# Work Order ID-93998

Item Name: Crosstube Turning Detail

<b>DART AEROSPACE LTD</b>	<b>Work Order:</b> 93998
<b>Description:</b> Crosstube Assembly (412 High Aft)	<b>Part Number:</b> D412-664-243
<b>Inspection Dwg:</b> D412-664-243 <b>Rev:</b> E	<b>Page 1 of 2</b>

DRAWING NO. D412-664-243	TITLE CROSSTUBE ASSEMBLY (412 HI AFT)	REV. E	DART AEROSPACE LTD ENGINEERING ORDER		D.E.O. NO. D412-664-243-E-1	SHEET NO. SHEET 1 OF 2	SCALE NTS
DRAWN	CHECKED	MFG. APPR.	APPROVED	DE APPR.			
DATE 11.03.31	DATE 11/03/31	DATE 11.03.31	DATE 11/03/31	DATE 11.03.31

**D412-664-243  
ASSEMBLY DETAIL**

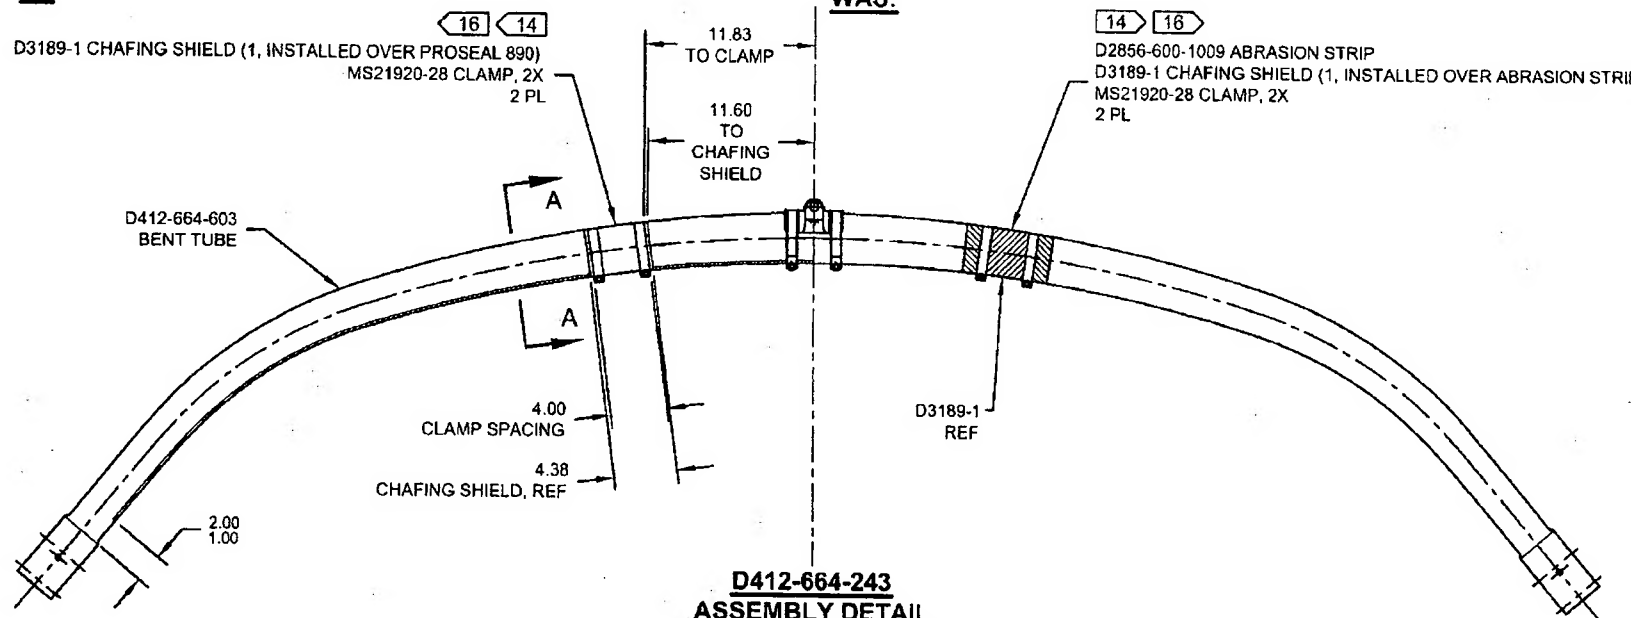
DRAWING NO. D412-664-243	TITLE CROSSTUBE ASSEMBLY (412 HI AFT)	REV. E	DART AEROSPACE LTD ENGINEERING ORDER	D.E.O. NO. D412-664-243-E-4	SHEET NO. SHEET 2 OF 3	SCALE NTS
DRAWN 90	CHECKED	MFG. APPR.	APPROVED	DE APPR.		
DATE 12.08.21	DATE 12.08.27	DATE 12.08.29	DATE 12.08.29	DATE 12.08.29

**IS:**

D3189-1 CHAFING SHIELD (1, INSTALLED OVER PROSEAL 890)  
MS21920-28 CLAMP, 2X  
2 PL

**SECTION A-A**  
CHAFING SHIELD DETAIL  
VIEW ROTATED, NOT TO SCALE

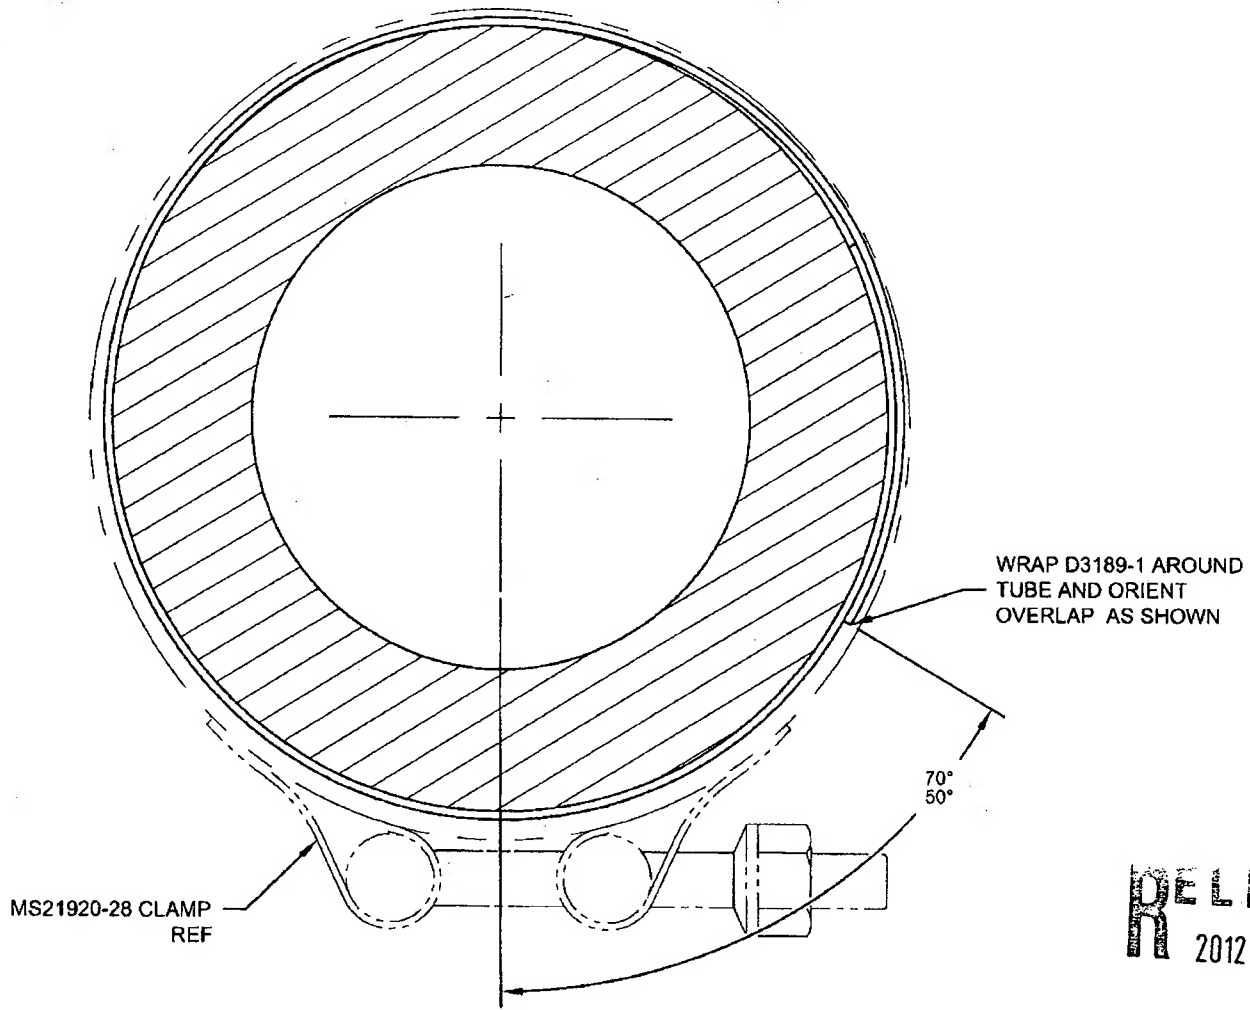
DRAWING NO. D412-664-243	TITLE CROSSTUBE ASSEMBLY (412 HI AFT)	REV. E	DART AEROSPACE LTD ENGINEERING ORDER	D.E.O. NO. D412-664-243-E-4	SHEET NO. SHEET 3 OF 3	SCALE NTS
DRAWN 92	CHECKED	MFG. APPR.	APPROVED	DE APPR.		
DATE 12.08.21	DATE 12.08.22	DATE 12.08.29	DATE 12.08.29	DATE 12.08.29
